TRANS/WP.29/2002/71
28 August 2002

PROPOSAL FOR DRAFT 02 SERIES OF AMENDMENTS
TO REGULATION No. 95

(Lateral collision protection)

Transmitted by the Working Party on Passive Safety (GRSP)

Figure 1

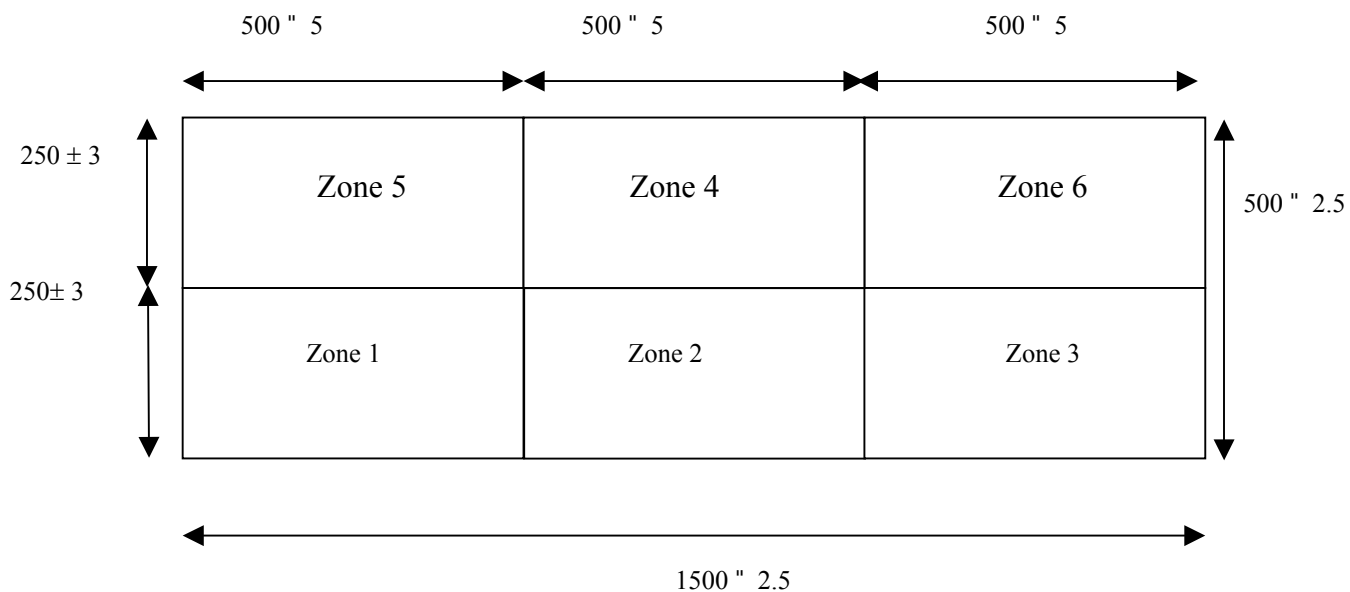
2.1.1.1. The impactor consists of 6 joined zones whose forms and positioning are shown in figures 1 and 2. The zones are defined as 500 ± 5 mm x 250 ± 3 mm in figures 1 and 2. The 500 mm should be in the W direction and the 250 mm in the L direction of the aluminium honeycomb construction (see figure 3).

2.1.1.3. The blocks must be centred on the six zones defined in figure 1 and each block (including incomplete cells) should cover completely the area defined for each zone).

Figure 2

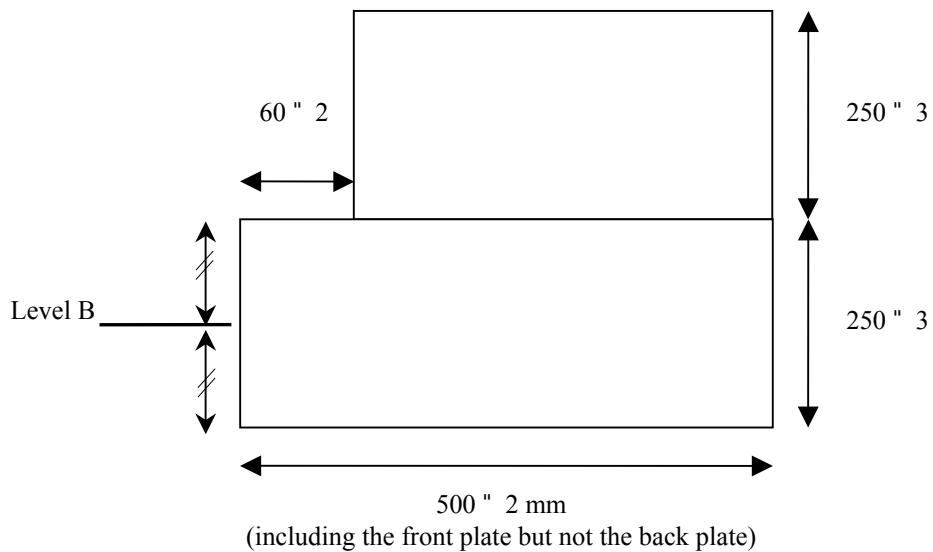
2.1.1.2. The impactor is divided into 2 rows. The lower row shall be 250 ± 3 mm high, and 500 ± 2 mm deep after pre-crush (see paragraph 2.1.2.), and deeper than the upper row by 60 ± 2 mm.

2.1.2.2. Blocks 1, 2 and 3 should be crushed by 10 ± 2 mm on the top surface prior to testing to give a depth of 500 ± 2 mm (figure 2).

- 2.2.1. Geometrical characteristics
 - 2.2.1.1. The front plates are $1,500 \pm 1$ mm wide and 250 ± 1 mm high. The thickness is 0.5 ± 0.06 mm.
 - 2.2.1.2. When assembled the overall dimensions of the impactor (defined in figure 2) shall be: $1,500 \pm 2.5$ mm wide and 500 ± 2.5 mm high.

Figure 4 - Dimension of Aluminium Honeycomb Cells

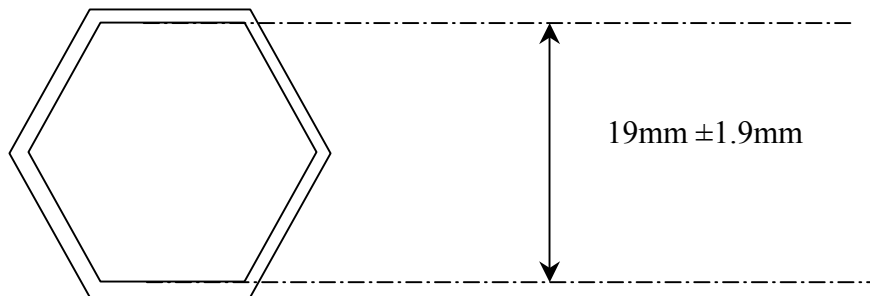
2.1.3.1. The cell dimensions shall be 19 mm ± 10 per cent for each block (see figure 4).

Figure 5

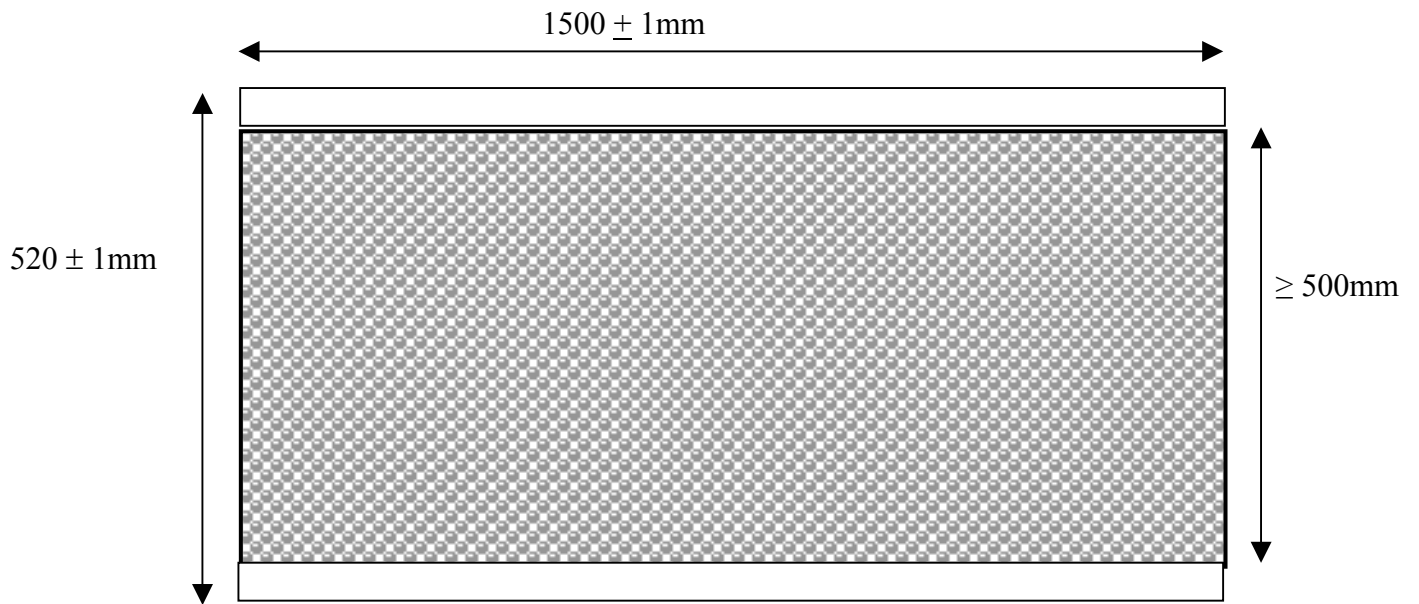
- 2.3.1. Geometric characteristics
 - 2.3.1.1. The geometric characteristics shall be according to figures 5 and 6.
 - 2.3.2. Material characteristics
 - 2.3.2.1. The back plate shall consist of a 3 mm aluminium sheet. The back plate shall be manufactured from aluminium of series AlMg₂ to AlMg₃ with a hardness between 50 and 65 HBS. This plate shall be perforated with holes for ventilation: the location, the diameter and pitch are shown in figures 5 and 7.

- 2.4. Location of the honeycomb blocks
 - 2.4.1. The honeycomb blocks shall be centred on the perforated zone of the back plate (figure 5).
- 2.5. Bonding

Figure 8

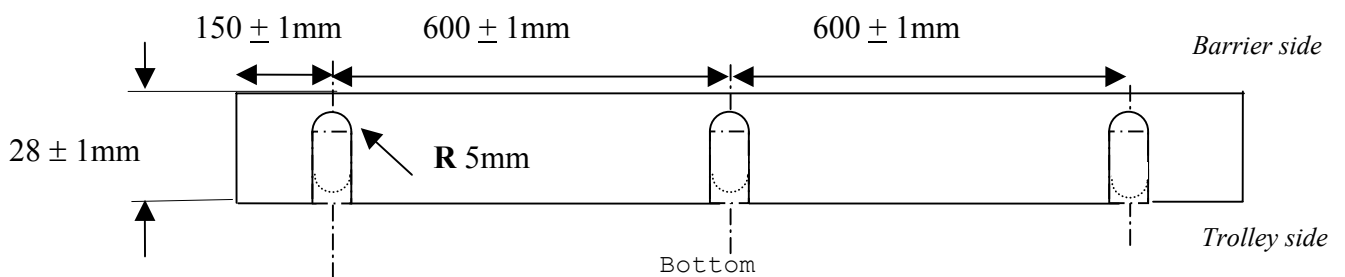
- 2.7.1. The fitting on the trolley must be according to figure 8. The fitting will use six M8 bolts, and nothing shall be larger than the dimensions of the barrier in front of the wheels of the trolley. Appropriate spacers must be used between the lower back plate flange and the trolley face to avoid bowing of the back plate when the attachment bolts are tightened.

Note: The attachment holes in the bottom flange may be opened to slots, as shown below, for ease of attachment provided sufficient grip can be developed to avoid detachment during the whole impact test.

Figure 9

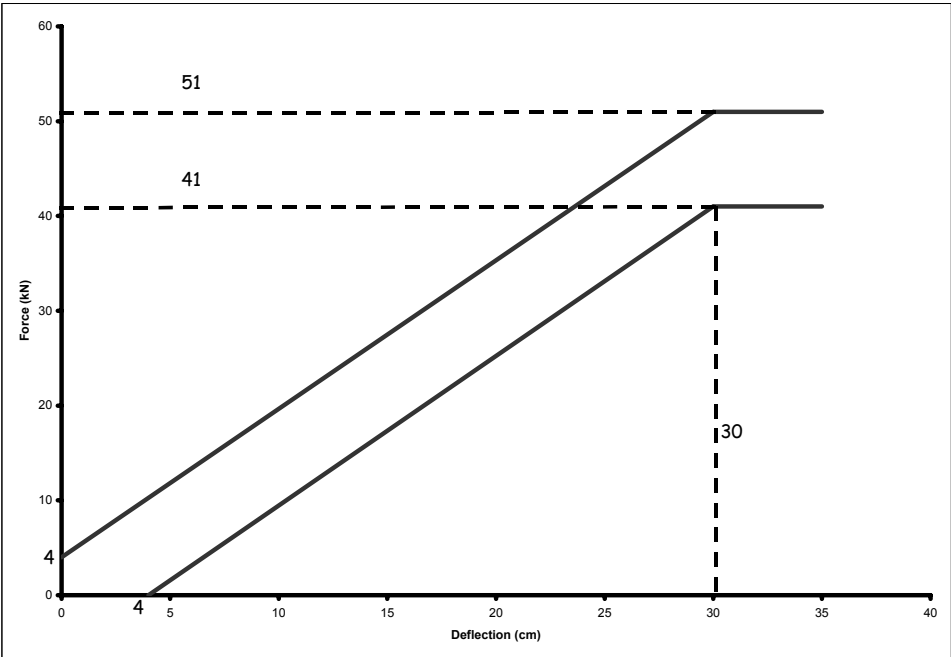
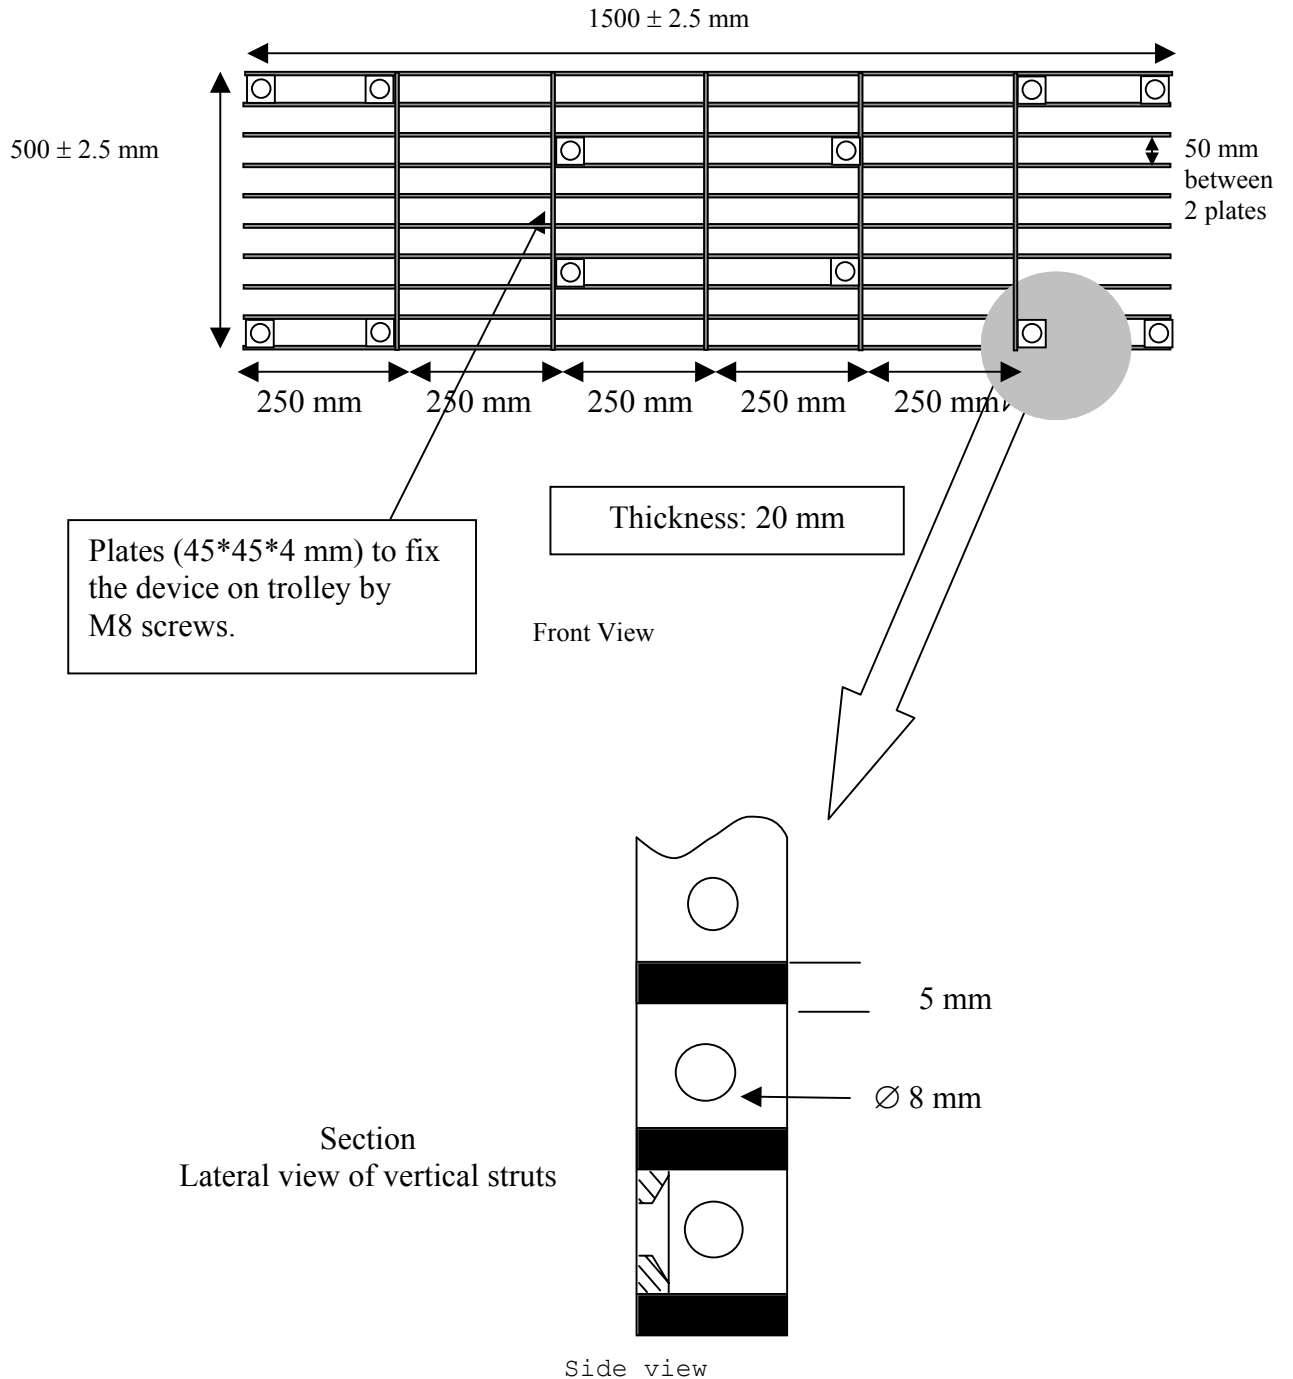
- 3.1. The interface between the trolley and the ventilation system should be solid, rigid and flat. The ventilation device is part of the trolley and not of the impactor as supplied by the manufacturer. Geometrical characteristics of the ventilation device shall be according to figure 9.

The ventilation device is a structure made of a plate that is 5 mm thick and 20 mm wide. Only the vertical plates are perforated with nine 8 mm holes in order to let air circulate horizontally.

Blocks 1 & 3
Figure 2a

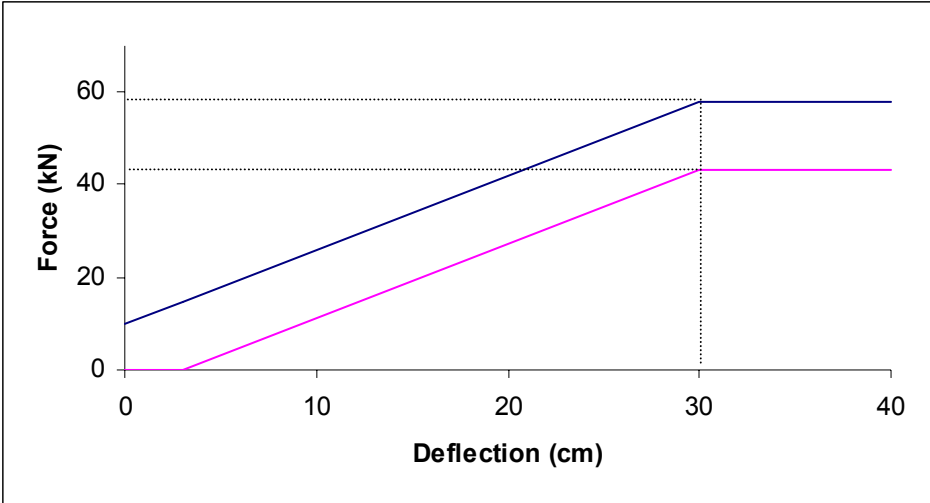
- 2.1.5.2.4. the sum of energy derived from deviating outside the corridor does not exceed 5 per cent of the gross energy for that block.
- 2.1.5.3. Blocks 1 and 3 are identical. Their rigidity is such that their force deflection curves fall between corridors of figure 2a.

Block 2
Figure 2b

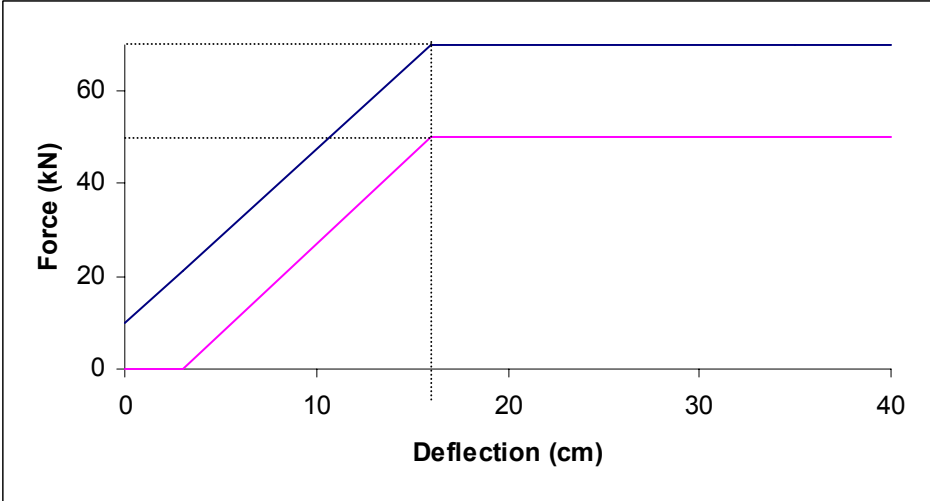
- 2.1.5.4. Blocks 5 and 6 are identical. Their rigidity is such that their force deflection curves fall between corridors of figure 2d.
- 2.1.5.5. The rigidity of block 2 is such that its force deflection curves fall between corridors of figure 2b.

Block 4
Figure 2c

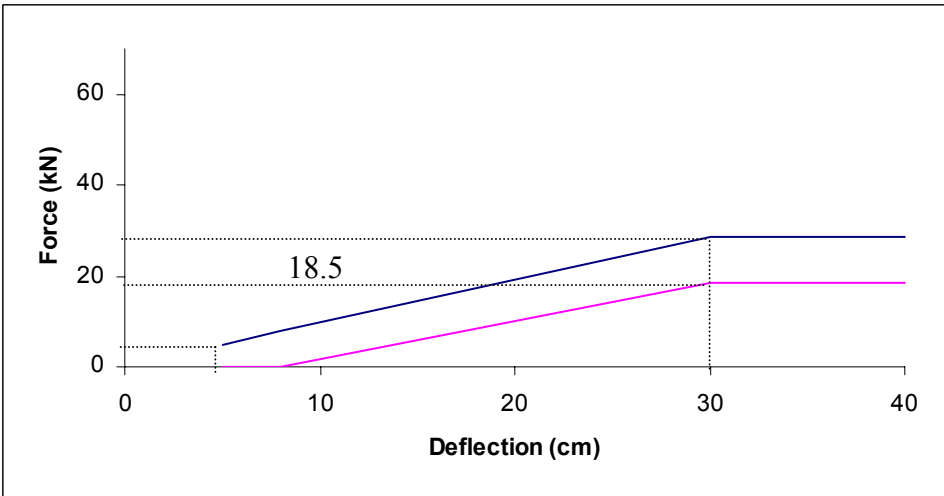
- 2.1.5.6. The rigidity of block 4 is such that its force deflection curves fall between corridors of figure 2c.
- 2.1.5.7. The force-deflection of the impactor as a whole shall fall between corridors of figure 2e.
